**La Casia-Barrios –
PLN2004-00398**

San Mateo County Board of Supervisor's Meeting

File Numbers: **PLN 2004-00398**

SUBJECT: Consideration of a Coastal Development Permit and Design Review, pursuant to Sections 6328.4 and 6565.3 of the County Zoning Regulations, to correct and mitigate the illegal removal of riparian vegetation performed in June 2004, and to allow the construction of a new 2,449 sq. ft. single-family residence with a 405 sq. ft. attached garage, and certification of a mitigated Negative Declaration, on an unimproved 7,070 sq. ft. parcel located on San Carlos Avenue in the unincorporated El Granada area of San Mateo County. This project is appealable to the California Coastal Commission. (Appeal of the Zoning Hearing Officer's decision for approval.)

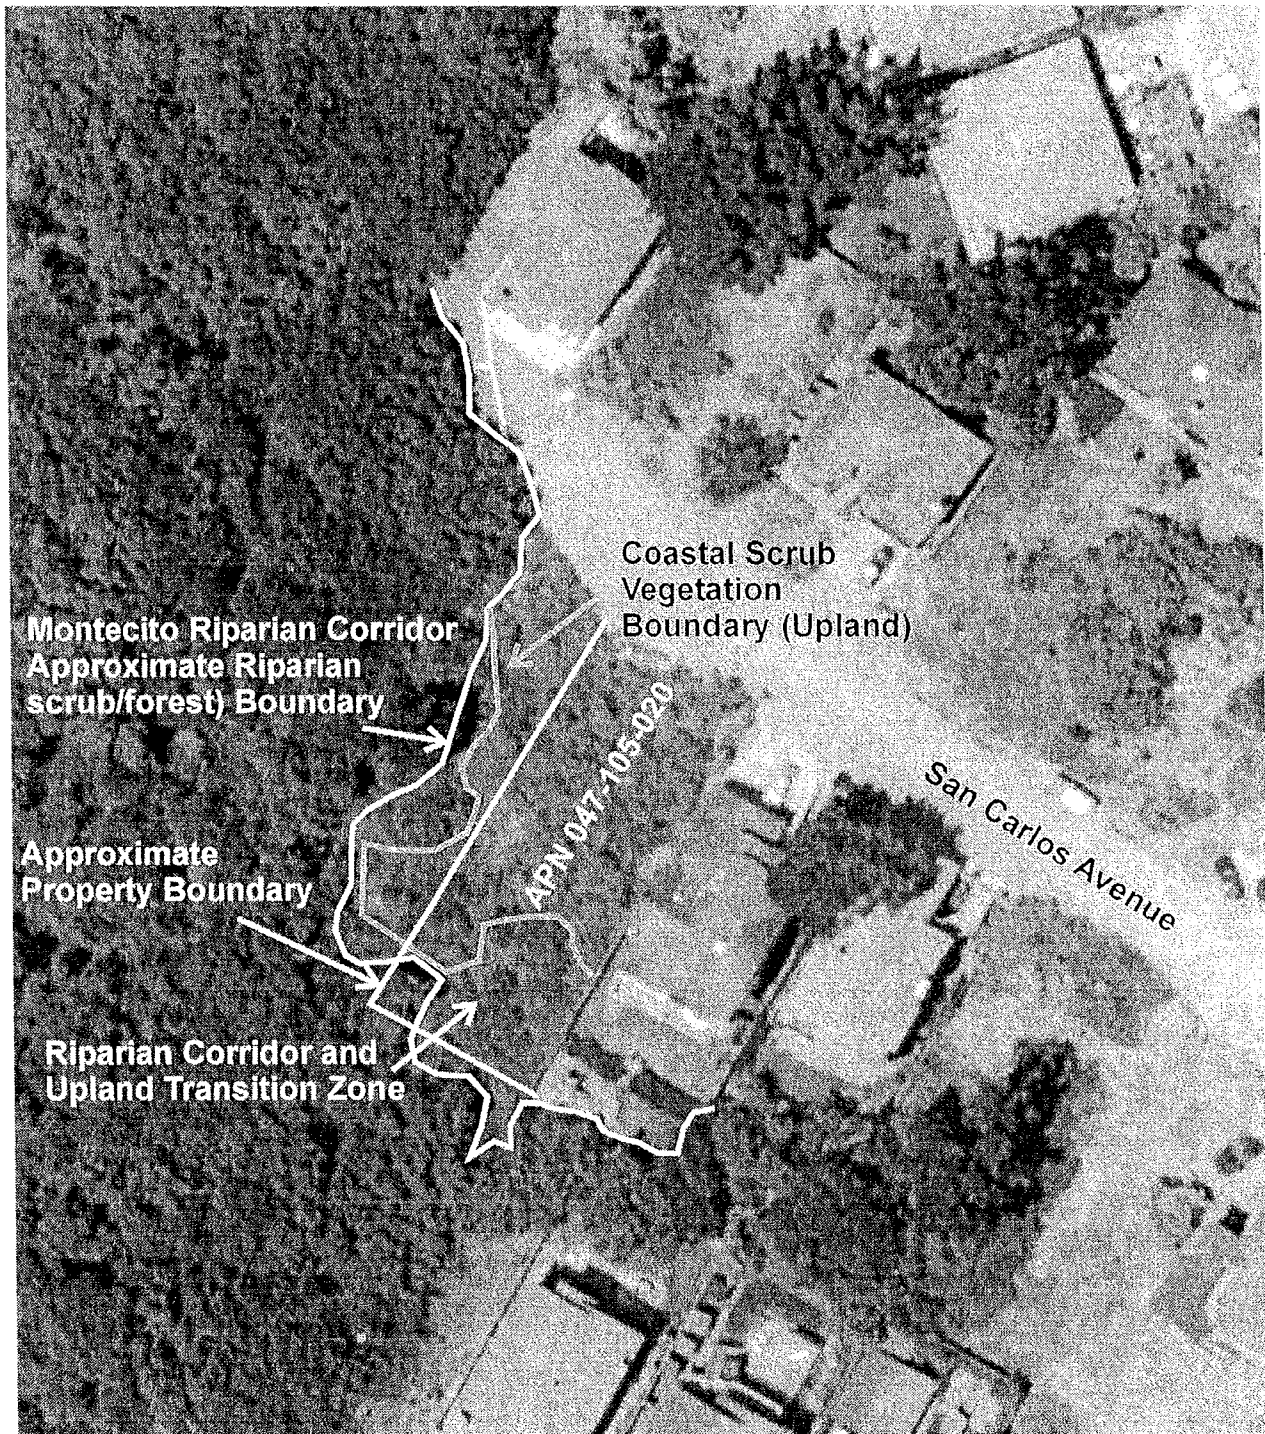
I believe the boundary between upland and riparian as mapped by Mr. Mahony in the October 15, 2004 report is consistent with the general vegetation boundaries present on the site in 2000, as shown in ([Figure 3](#)). Based on the coloration of the vegetation on the 2000 aerial photo, a clear boundary between upland and riparian vegetation is evident. The eastern and central portions of the property are brownish in color, in contrast to the dark green color of the dense willow trees within the Montecito Riparian Corridor. The dense riparian vegetation is primarily limited to the northern and western boundaries of the property, with a transition zone that likely included both riparian and upland vegetation on the western one-third of the property ([Figure 3](#)). Mr. Mahoney designated (approximately) the lower half of this transition zone to be riparian, and the upper half to be upland. I believe this to be a fair characterization of this transition area, where vegetation was cleared and there is no clear boundary today, and both upland and riparian plants are currently recolonizing. Though there is general agreement between the 2000 aerial photo in [Figure 3](#), and the 10/11/04 survey map, the 10/11/04 survey map should be considered a more precise delineation of the riparian boundary because it is based on vegetation, topography, and soil information observed in the field.

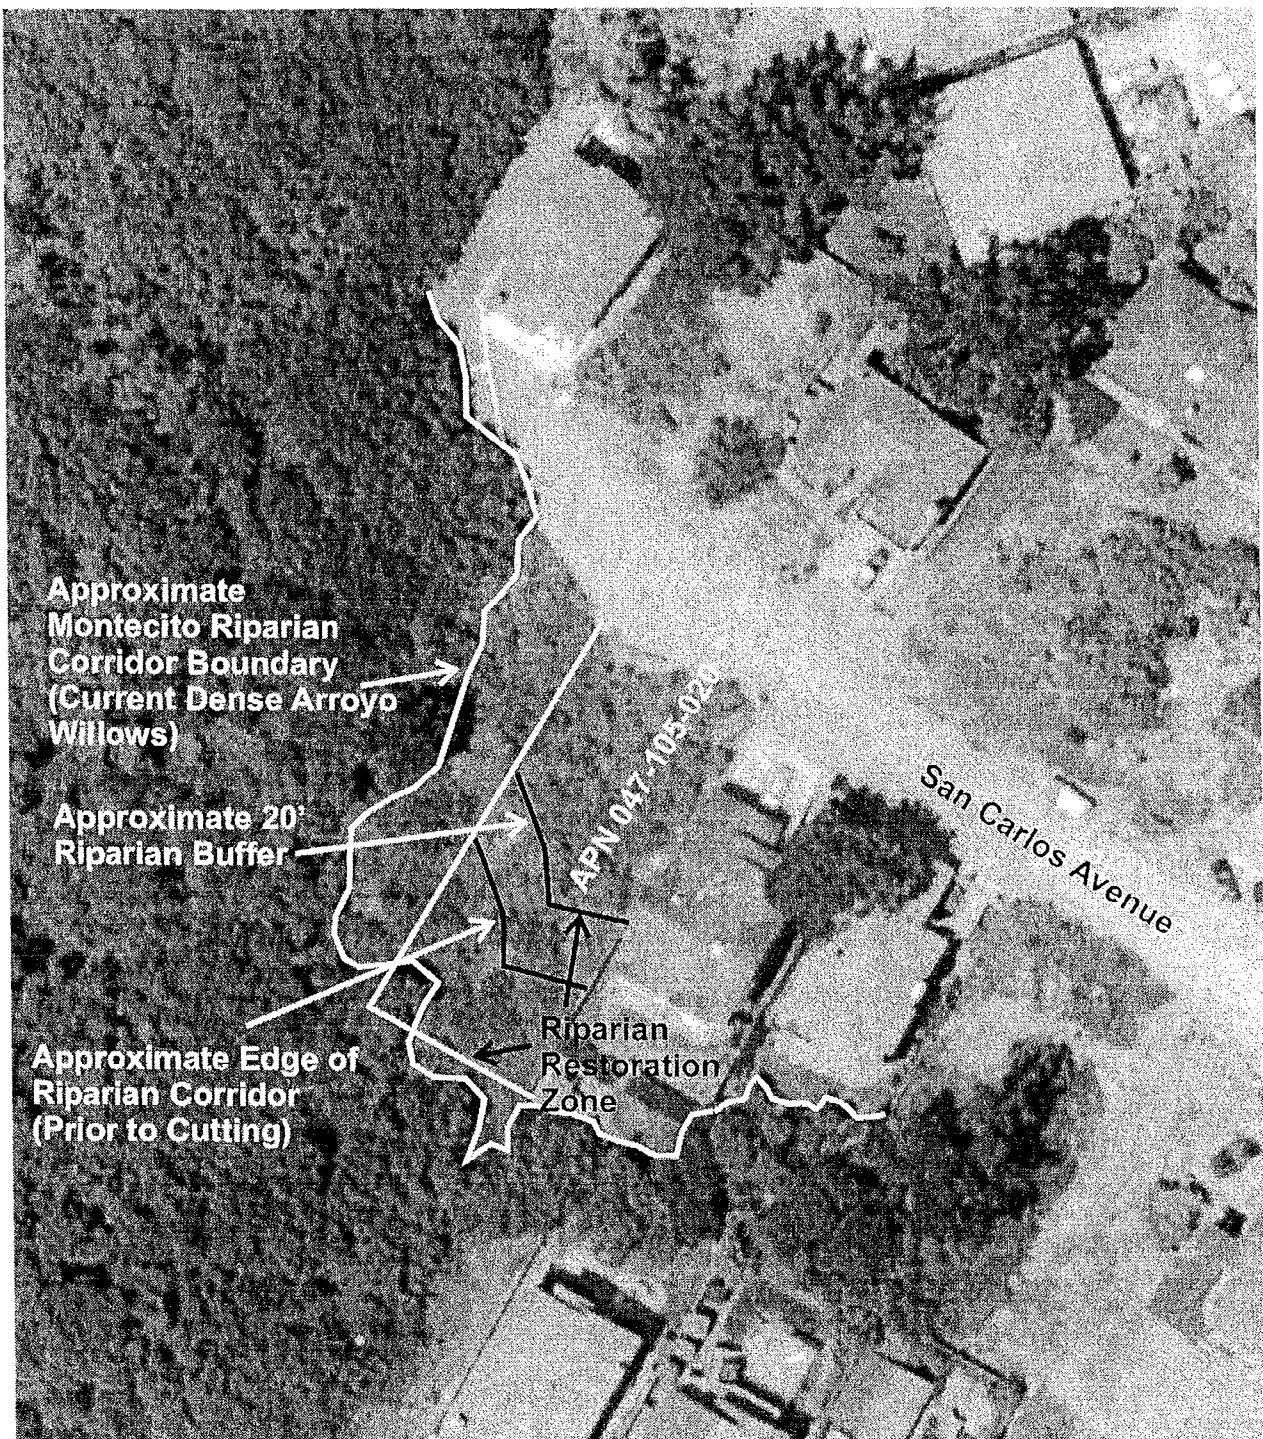
If restoration work is conducted on the site as proposed, riparian vegetation would be restored to the areas that had been previously cleared, and partially within a 20 foot buffer zone ([Figure 6](#)). This would create a band of riparian vegetation consistent and in excess of what was likely cleared from the site in 2000. Currently the site is in process of restoring itself, and in time as

Fig. 2

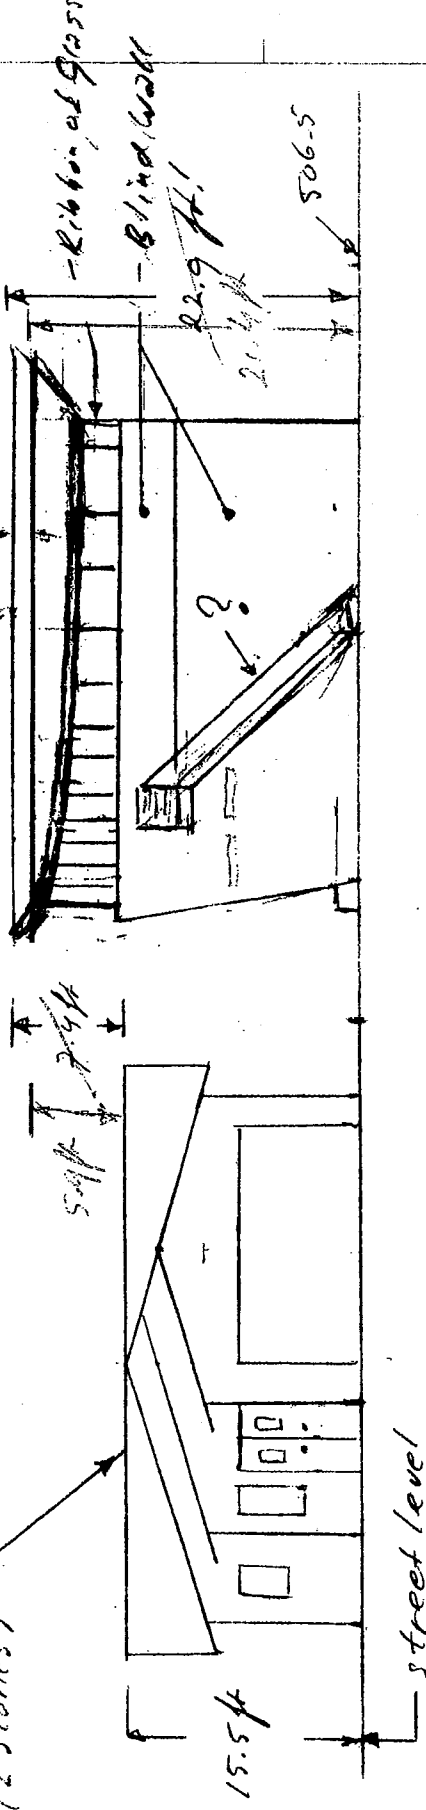
Fig. 1 shows that façade articulation is completely inadequate. The architect has attempted to show articulation in his drawing package (see sheet A201) by calling an oblique view the "Front Elevation." His front elevation is not what is seen from the street, but is the view at an 18 degree angle relative to the normal view from the street. Furthermore, the articulation as shown in the "East Elevation" (see sheet A202) is factually incorrect as the windows are, in reality, not moved back relative from the wall as may be seen from inspection of sheet A102. The view shown in Fig. 2 is correct and shows that articulation for this elevation is inadequate as well.
